9.2 COMMENT LETTERS

NOTICE OF PREPARATION OF DRAFT ENVIRONMENTAL IMPACT REPORT AND INITIAL STUDY FOR PLAZA LINDA VERDE, SAN DIEGO STATE UNIVERSITY

For your convenience we have attached a copy of Figure 1.0.2, Vicinity Map, from your EIR, and identified, using hash marks, the location of our development.

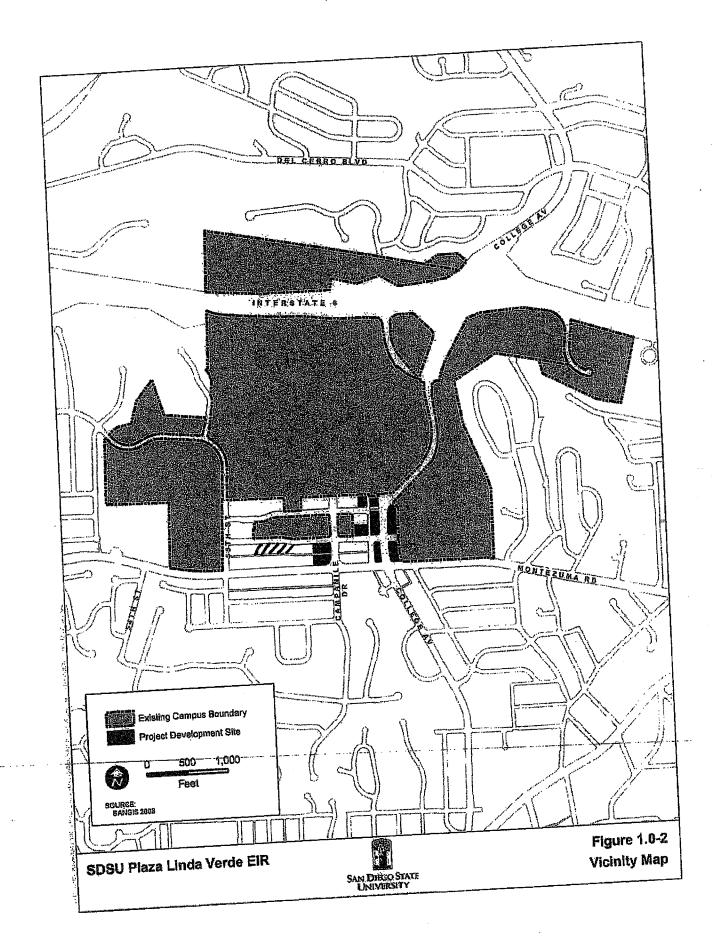
The purpose of this letter is to respectfully request you confirm: (1) our development is not included in the Proposed Project (2) our project is included in the SDSU Campus Master Plan boundary (3) you will notify us if the referenced EIR is amended to include our development and (4) you will notify us if our development is included in a subsequent EIR.
